DEFENSE NUCLEAR FACILITIES SAFETY BOARD

TOPIC NO. 91-007
REVIEW OF WSRC-TR-92-120
STRUCTURAL MODEL OF THE BASEMENT IN THE CENTRAL
SAVANNAH RIVER AREA, SOUTH CAROLINA, AND GEORGIA
SAVANNAH RIVER SITE
(TASK ORDER 001)

This Memo presents our comments on the report by Westinghouse Savannah River Company (WSRC) titled "Structural Model of the Basement in the Central Savannah River Area, South Carolina and Georgia," WSRC-TR-92-120, and references discussions at the Earth Science Advisory Committee (ESAC) on May 20, 1992. Their model has been developed primarily from geophysical images of the basement. The model describes the Pen Branch Fault as being a concave master fault which bounds the Dunbarton Basin laterally and from below. Our review questions validity of the model from a geological standpoint. Specifically, the mechanism and forces necessary to form the proposed structure are unlikely to have existed and the model does not fit well within the geologic history of the southeast.

FIGURE 2
 GEOLOGIC CROSS SECTION
 SAVANNAH RIVER SITE
 AIKEN, SOUTH CAROLINA

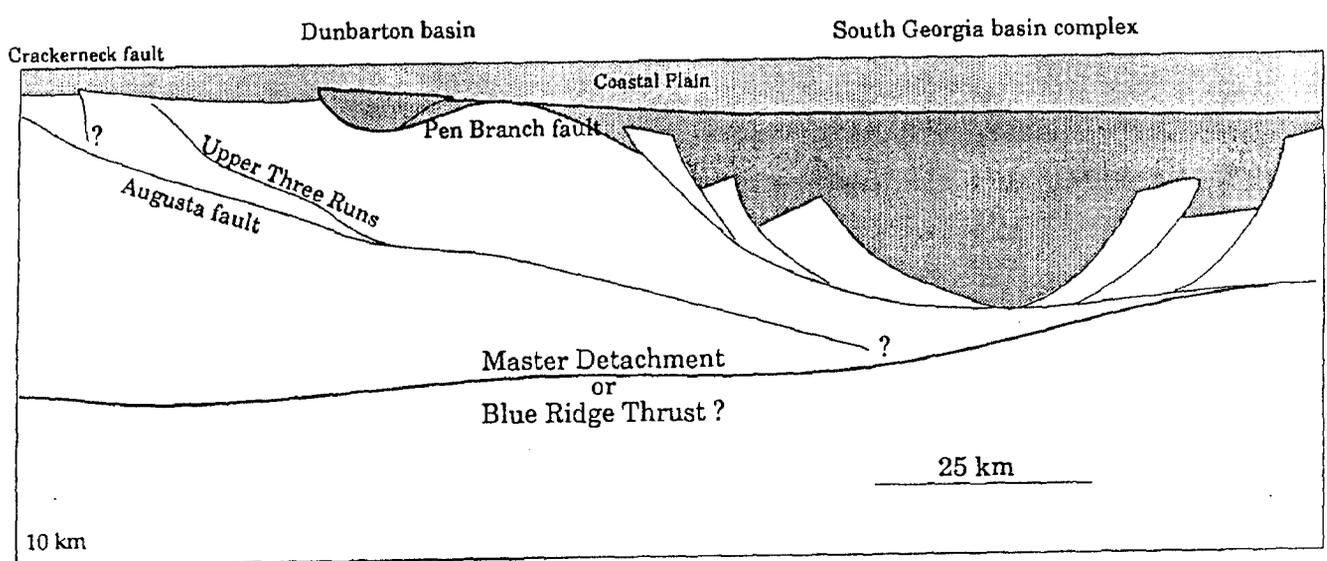
2. The basement model does not adequately explain the geometry of the faults near the Savannah River Site. The most troublesome aspect of the model is the geometry of the Pen Branch Fault as it relates to the Dunbarton Basin. The Dunbarton Basin is one of many basins which originated under an extensional stress regime during the Mesozoic. The authors acknowledge that this extensional regime existed, but do not deal with all the implications. For example, the entire crust must have been in a state of extension. Any fault must extend deep within the crust and would have offset any deep, older structure. The Dunbarton Basin formed because that particular area of the crust was relatively weak. This relative weakness is probably at the base of the brittle crust and more than 20 km deep. The bounding faults most likely extend very steeply into the deep basement and would offset any underlying Paleozoic thrust fault. Therefore, the faults bounding the Dunbarton basin cannot be the shallow concave structures shown on Figure 2 under such a regime.
